SUBJECT: NuScale Power, LLC Submittal of the Approved Version of NuScale Topical

Report, "Statistical Subchannel Analysis Methodology Supplement 1 to TR-0915-17564-P-A, Revision 2, Subchannel Analysis Methodology,"

TR-108601- P-A, Revision 4

SAFETY EVALUATION BY THE OFFICE OF NUCLEAR REACTOR REGULATION TOPICAL REPORT TR-108601-P, REVISION 4,

Figure 3-3 VIPRE-01 Radial Nodalization

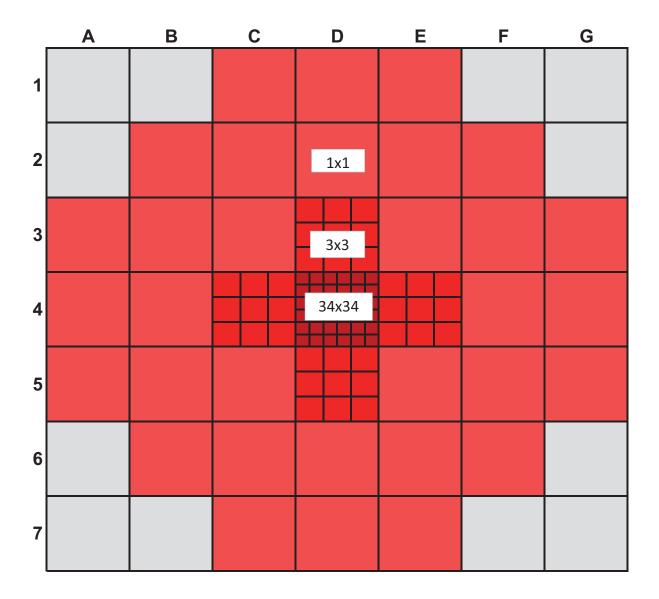
While the NSAM had multiple radial nodalization schemes approved, only one radial nodalization scheme is requested for approval in the SSAM submittal. This scheme models one full assembly at the center of the core with nodalization at the subchannel level. This assembly is surrounded on four sides by other assemblies which are modeled with the nodalization at the lumped subchannel level (i.e., multiple fuel subchannels are lumped into a single subchannel for computation). Each of these assemblies is further surrounded by other assemblies which are modeled with the nodalization at a lumped assembly level (i.e., all subchannels in the fuel assembly are lumped into a single subchannel for computation). This nodalization scheme is similar to the basemodel and the Lump51 model from the one-eighth nodalization approved in the NSAM topical report.

In order to demonstrate that this radial nodalization could accurately capture the critical linear heat generation rate (LHGR), NuScale performed a sensitivity study in Section 6.4.1 of the SSAM submittal (Reference 13). That study demonstrated that the radial nodalization proposed resulted in {{ }} compared to a full core radial nodalization. Because of this and because a full core radial nodalization is a radial nodalization approved in the NSAM, the NRC staff has determined that the radial nodalization is acceptable.
